Current Zoning: MUDD-O (mixed use development, optional)
Proposed Zoning: MUDD-O SPA (mixed use development, optional, site plan amendment)

Approximately 2.11 acres located on the north side E. Independence Blvd, Pierson Dr, Bamboo St. and Wilshire Pl.

The petition proposes an amendment to the previously approved rezoning petition to allow the reuse of an existing building and additional redevelopment on the site. The proposal would modify the conditions related to signage and additions to the existing building that remains.

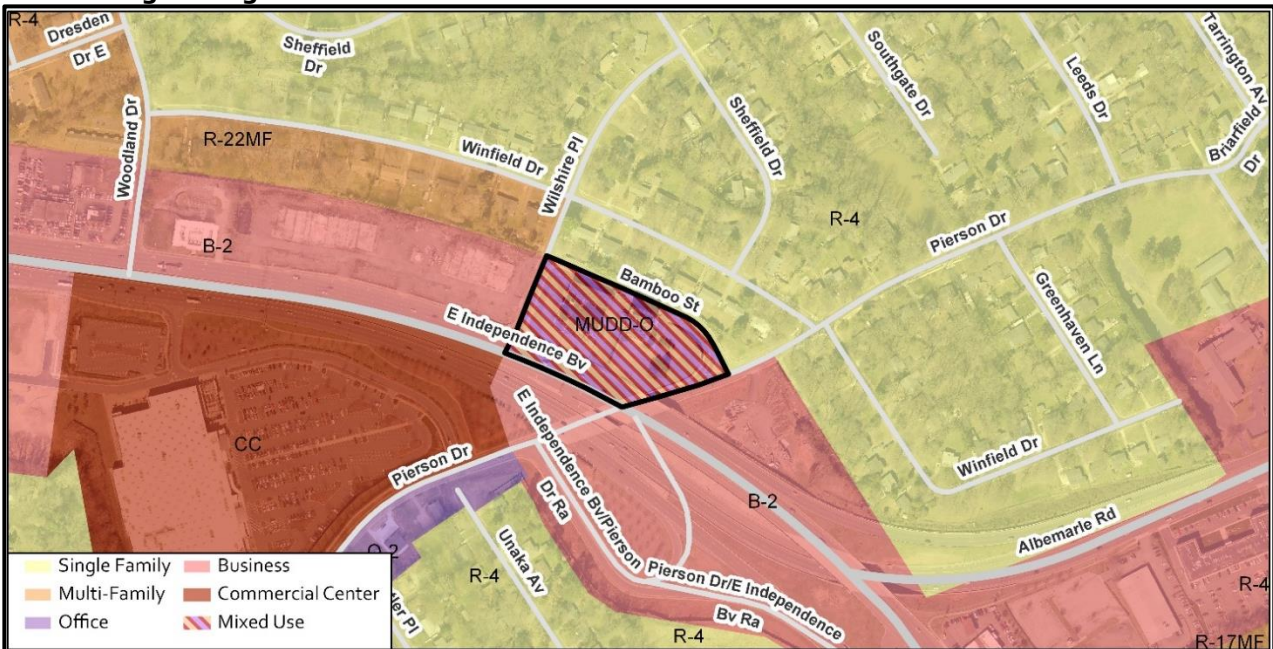
3. ~~Add a conditional note to specifying replacement of the existing CATS bus stop pad as indicated by the site plan.~~ Addressed
 4. ~~Revise the site plan (RZ-2) to show the existing stairs that are shown in the sidewalk area along Bamboo Street to be removed from the right-of way. In addition, please propose to install a safety rail or a gated system to prevent pedestrians, within in the right-of way, from falling into the drop-off.~~ Addressed

5. ~~Revise the site plan (Sht. RZ-2) to clarify whether the existing driveways on Bamboo Street will remain or be replaced. Sheet RZ-2 calls for the existing driveways to remain, but the site plan shows the existing Commercial Type II Driveway to be replaced with a Type II Modified Driveway at the access west of the existing Ervin building.~~ Addressed

6. ~~Revise the site plan (RZ-2) to include proposed and existing sidewalk labels and dimensions.~~ Addressed
-
